Appendix B to Staff Report SRPI.21.008

SUBJECT: Official Plan Amendment and Zoning By-Law Amendment Application

Legal Description: PLAN 1642 E PT LOT 3
Municipal Address: 11130 Yonge Street

Town File No.: D01-18001 D02-18007

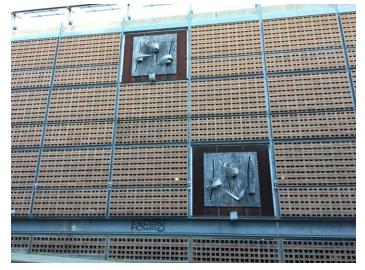
- 4. The architectural treatment of the facades of the parking levels needs to be enhanced and appropriate for a street wall fronting Yonge Street. The Applicant should refer to the design guidelines under the "Above-Grade and Underground Parking Structures" in Section 5 (Site Design) of the City Wide Urban Design Guidelines. Please consider the precedent images below and within the City Wide Urban Design Guidelines as examples.
